ATTACHMENTS FOR COUNCIL MEETING

Herring Road Urban Activation Precinct

August 12, 2014

City of Ryde

Figure 1: 2031 Morning Peak Hour Volume Estimates

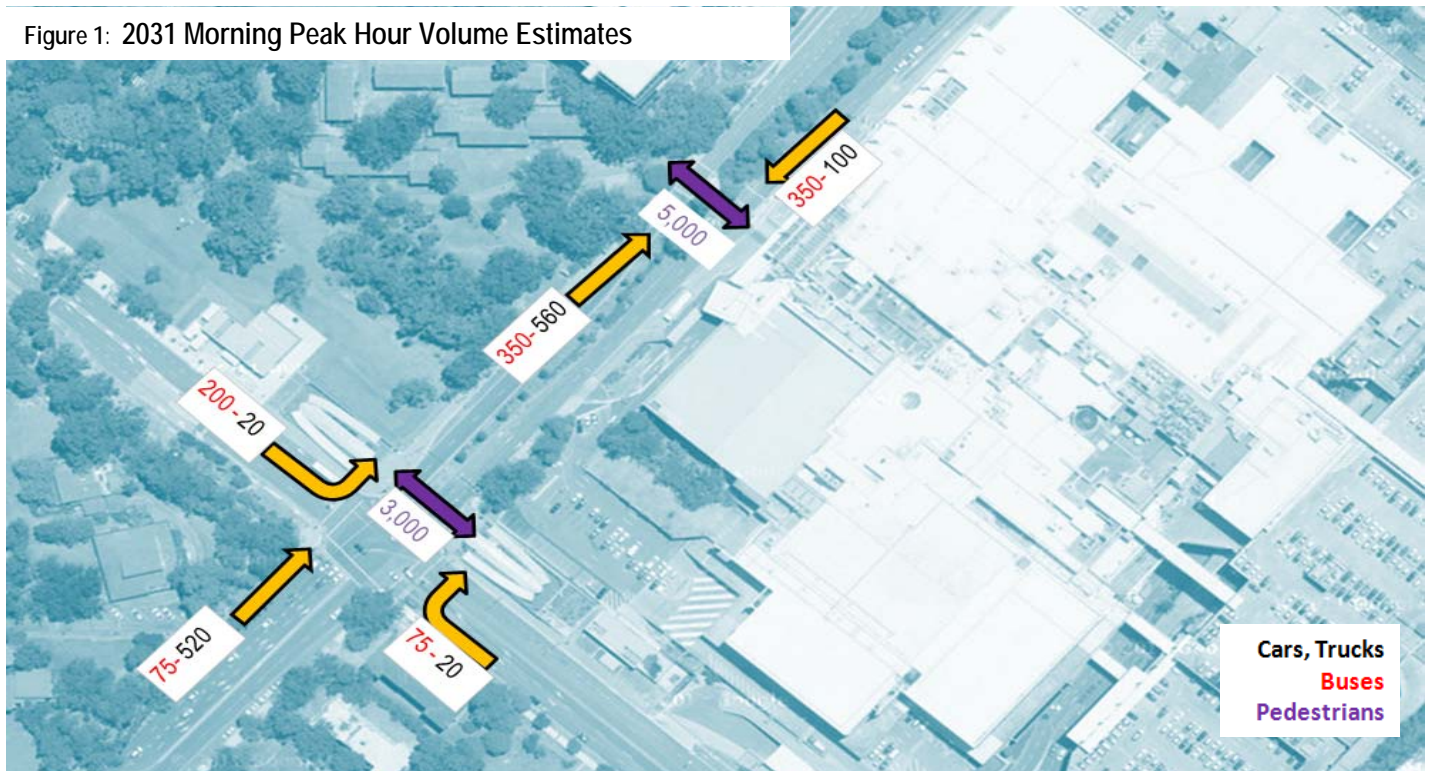
The volume estimates presented in Figure 1 show significant conflicts between buses, cars and pedestrians at both the existing signalised pedestrian crossing and the intersection of Waterloo Road and Herring Road.

Figure 1 shows that approximately 350 buses per hour would be required to access the Macquarie Interchange; a significant increase from the 50 buses per hour currently using the interchange.
